Montgomery Planning Historic Preservation

Case I.K

7835 River Road, Bethesda

Magruder's Blacksmith Shop

LEFT SIDE ELEVATION

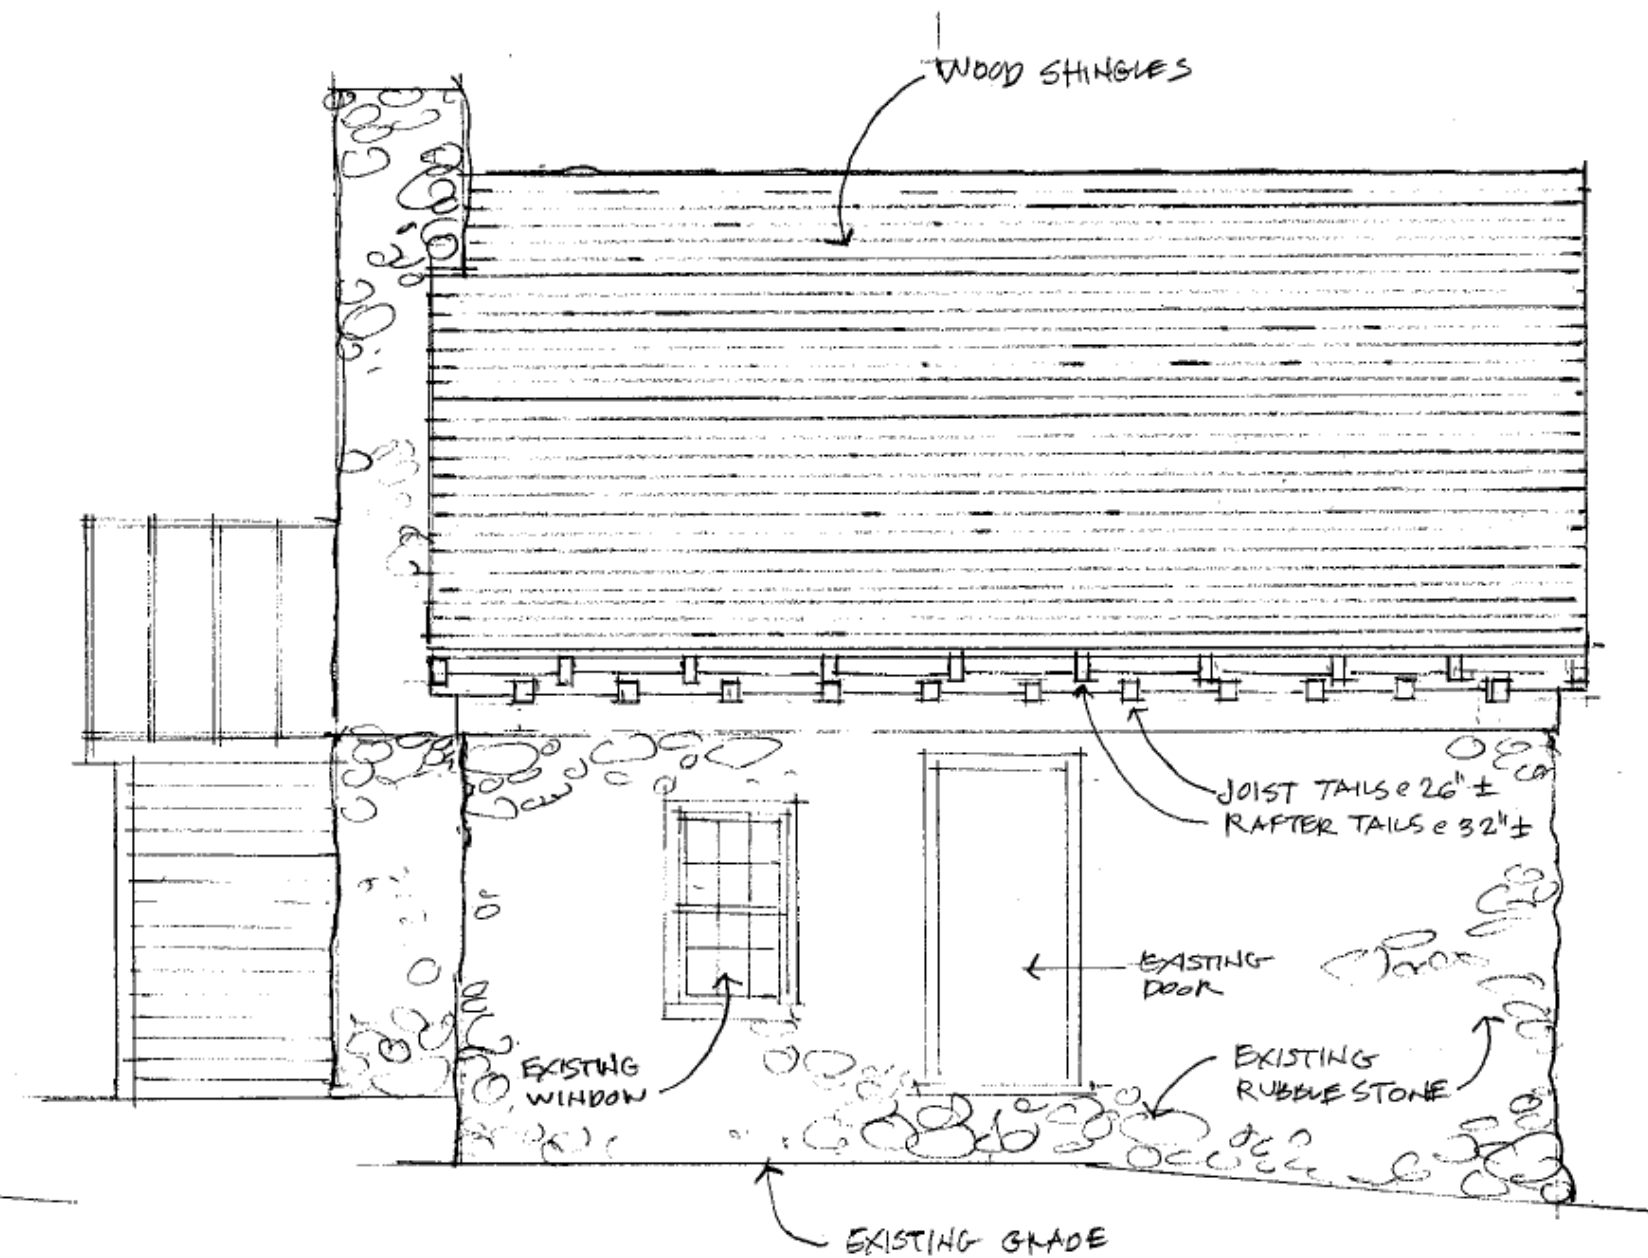
- Wood shake roofing is proposed for main building and proposed dormers.
- Option B (two dormer option) is proposed.
 - Wood shingles are proposed for the two dormers.
 - Wood true divided lite windows are proposed for the two dormers.
- As part of the roof reconstruction, the eaves will be rebuilt, with exposed joist and rafter tails to match the original, which have deteriorated beyond repair.
- Proposed roofing details have been provided.
- The existing copper roofing on the non-original attached shed to the northwest (left) side of the main building will remain.

- Although the HPC found that none of the installed copper elements are appropriate, the applicants propose to retain the copper roofing that was previously installed on the non-original attached shed to the northwest (left) side of the main building.
